PIC18F2525/2620/4525/4620 Rev. A3 Silicon Errata

The following silicon errata apply only to PIC18F2525/2620/4525/4620 devices with these Device/Revision IDs:

FIGURE 1: SCK PULSE VARIATION USING TIMER2/2

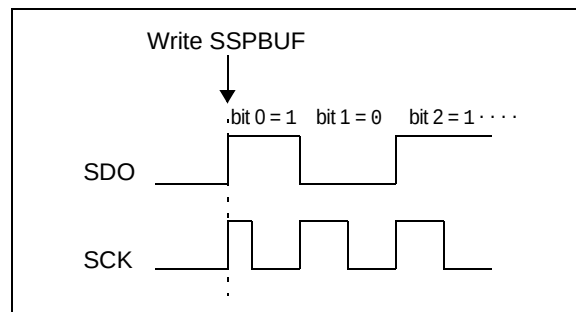
When the SPI is using Timer2/2 as the clock source, a shorter than expected SCK pulse may occur on the first bit of the transmitted/received data (Figure 1).

To avoid producing the short pulse, turn off Timer2 and clear the TMR2 register, load the SSPBUF with the data to transmit and then turn Timer2 back on. Refer to Example 5 for sample code.
